**Subject: Application for Modification to Section 401 Water Quality Certification and Neuse Riparian Buffer Certification:** Widening of Interstate 85 from west of US 15-501 to west of Broad Street, Durham County, Division 5; TIP No. I-0306C; State Project No. 8.1414801; Federal Aid Project No. I-85-4(49)174. USACE Action ID No. 20220949; NCDENR-DWQ Water Quality Certification No. 3411; \$475.00 Debit WBS Element 34143.1.1.

The purpose of this submittal is to request a modification to the Section 401 Water Quality Certification and Neuse Buffer Certificate. This modification is for changes to buffer impacts through utility design changes and stormwater design changes including changes in pipe sizes at several locations due to construction feasibility. The stormwater design changes are described in this permit modification application to adhere to Condition No. 13 in the Section 401 Water Quality Certification No. 3411, dated February 5, 2003. This condition states "*No changes to the horizontal or vertical placement of the stormwater outfall locations, the horizontal or vertical placement of the culverts, the horizontal or vertical placement of bridges, the horizontal or vertical

Rev  
 SHEET 6 OF 21  
 9/2/04

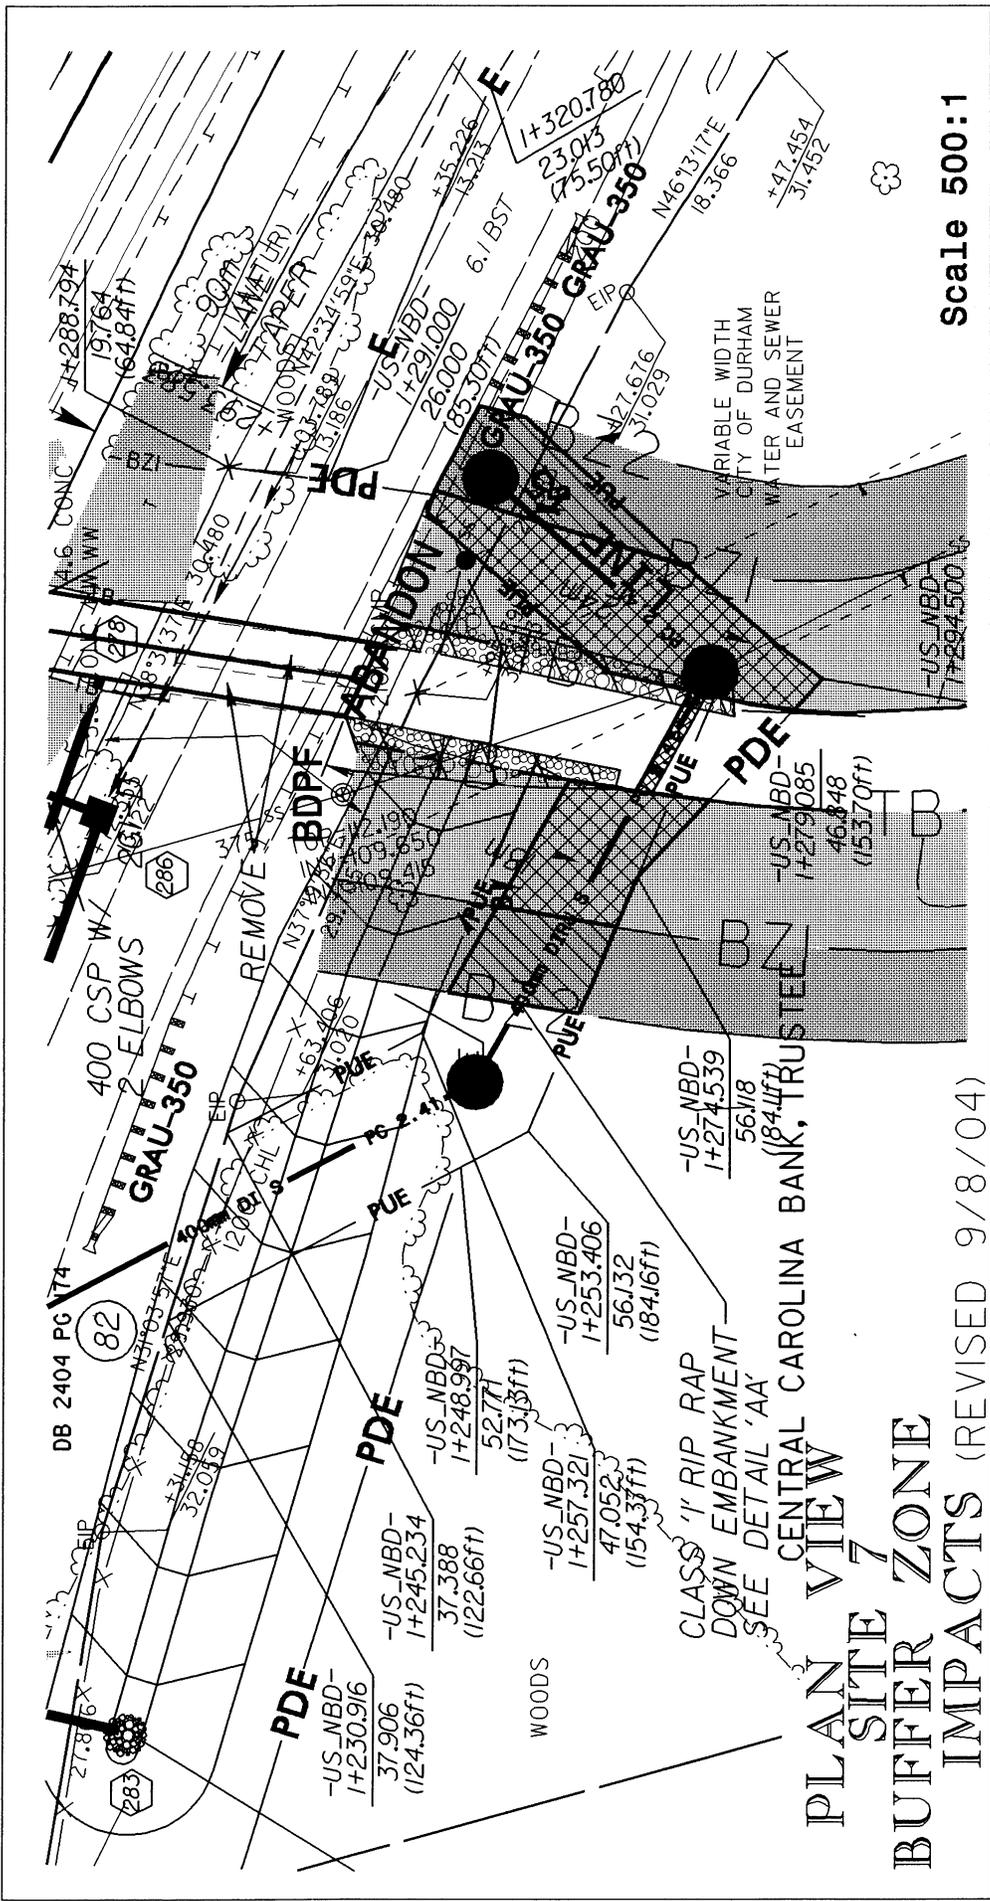
The original Permit Drawing had a 900 mm stormwater pipe going over the proposed culvert. This size pipe could not clear the culvert. The Permit Drawing and plan sheet were revised to two 750 mm pipes over the culvert. No additional buffer impacts will occur at this site.

PLAN VIEW  
SITE 7A  
BUFFER ZONE  
IMPACTS (REVISED 9/8/04)

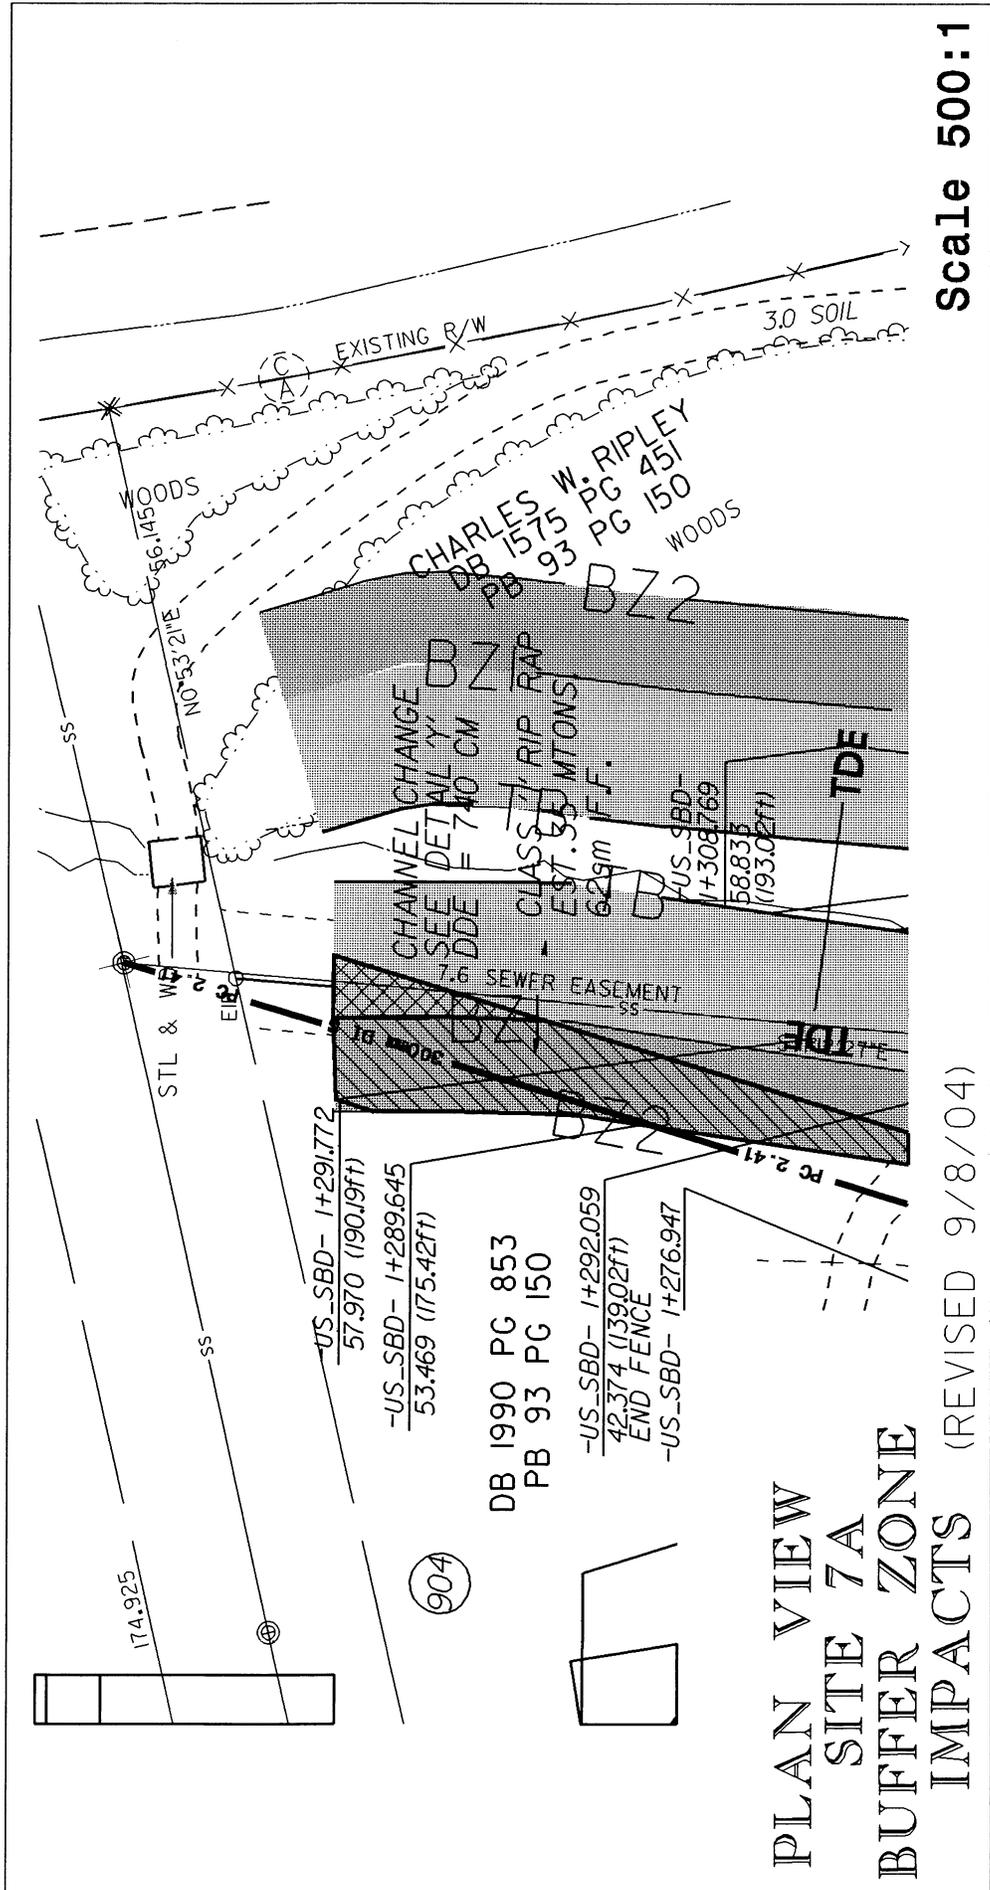
During construction it was determined that the grade of the sewer line at this Site was too high at the proposed location. Therefore, the sewer line has changed to tie into another existing line at a lower elevation. Zone 1 impacts were reduced by 236 sq ft and impacts in Zone 1 are now 303 sq ft. Buffer impacts increased in Zone 2 by 1247 sq ft and buffer impacts in Zone 2 are now 1988 sq ft.

This Site originally had a perpendicular crossing through the buffers. According to the Neuse Riparian Buffer rules, these original impacts are allowable and NCDOT did not originally mitigate for these buffer impacts. The design change has now caused the crossing in the buffers to be other than perpendicular and so now mitigation is required for the Zone 1 impacts. Zone 2 impacts are allowable.

**SHEET 13 OF 14**

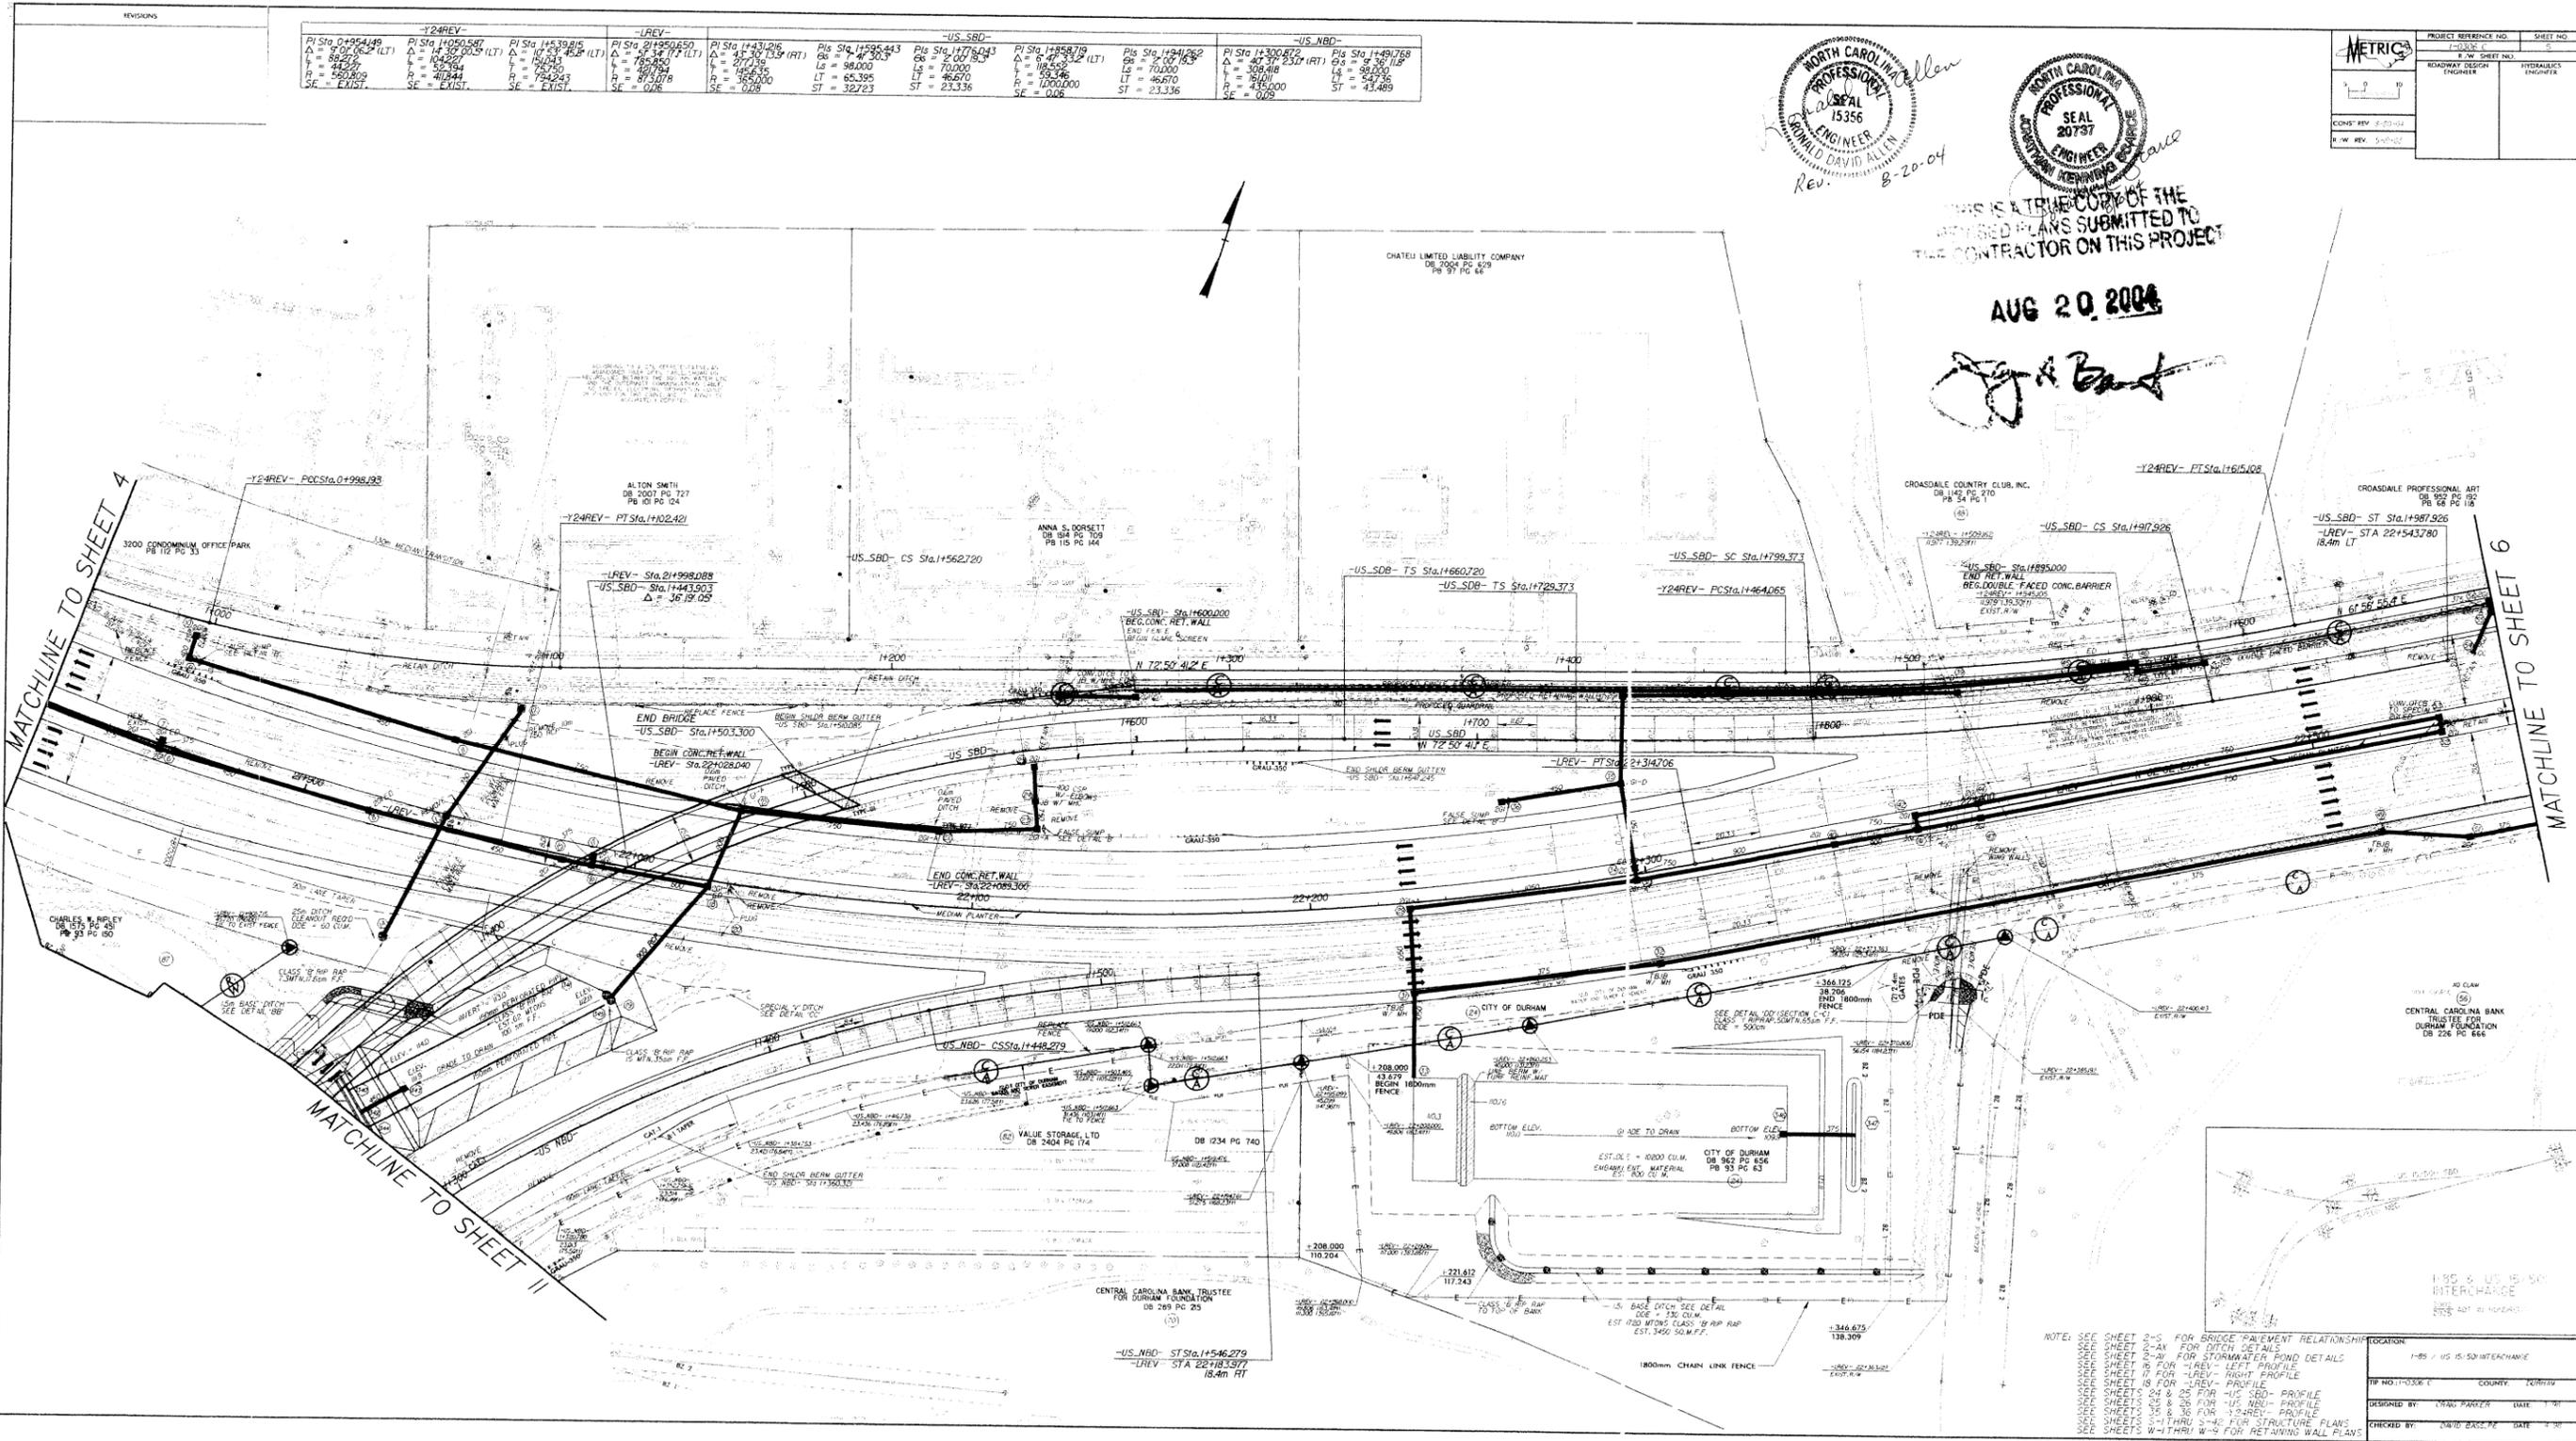
CONST. REV. - VARIOUS DRAINAGE REVISIONS FROM STRUCTURE NUMBERS 29 TO 53. (8-20-04)BCK
